NUCLEAR REGULATORY COMMISSION

Title: 650th Meeting of Advisory Committee on
Reactor Safeguards

Date: February 8, 2018

NuScale Design Certification Application Request
for Exemption from General Design Criteria 27

Simplified CVCS Diagram

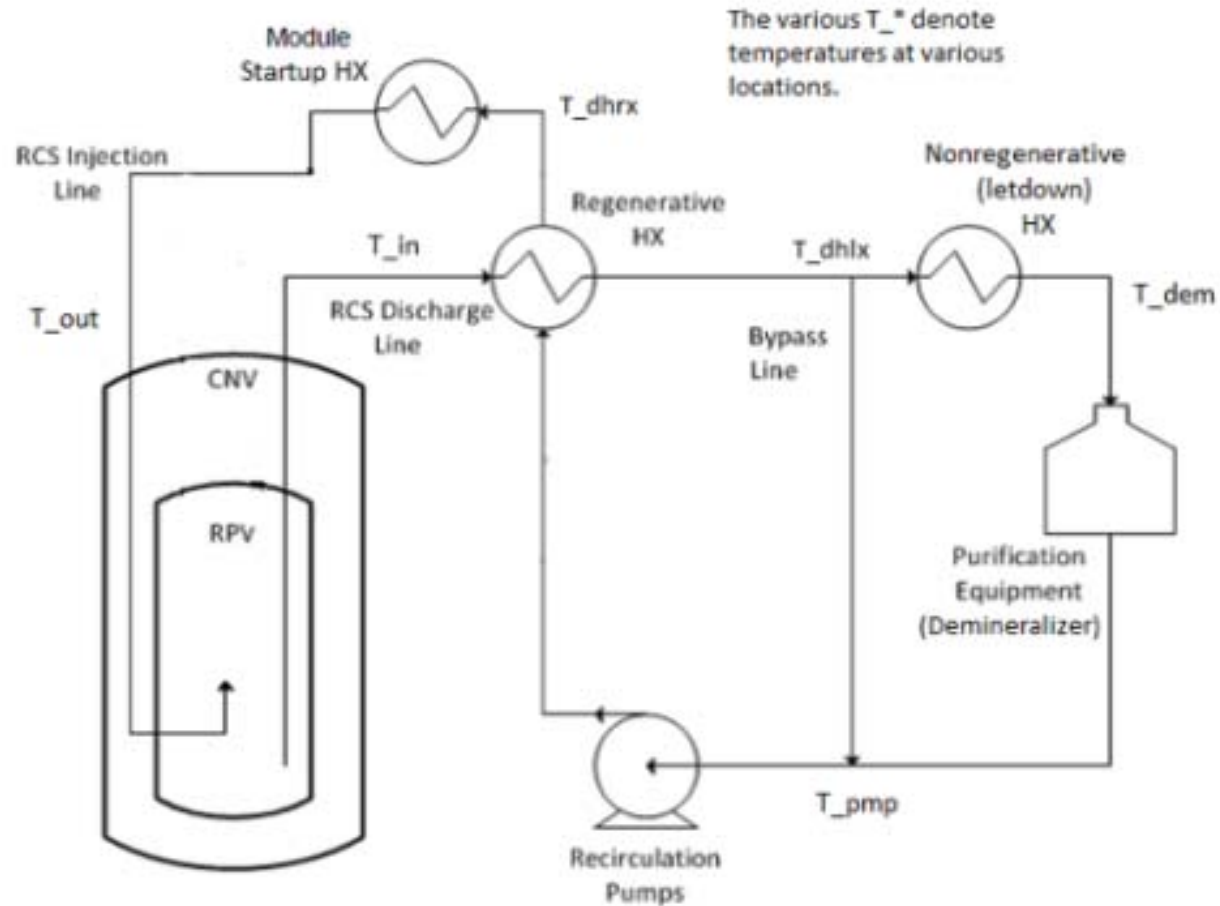
2 MEMBER MARCH-LEUBA: Before we run out of
3 time and they don't let me ask you a question, can you
4 go forward to slide 12, one of the backup slides?
5 Because I know I'm being polite, I kept quiet and then
6 when I ask a question, he doesn't let me ask it.

9 So, the CVCS injects into the vessel,
10 correct?

1 comment I made, I'll be curious for the analysis that
2 shows your capability to use CVCS to raise boron
3 concentration to that level that provides the hold
4 down that compensates for the stuck rod.

13 MR. BOTHA: Yes, and I think the short
14 answer for today is, it's long, but it's small in
15 comparison to the time you have before you get to
16 return to power condition.
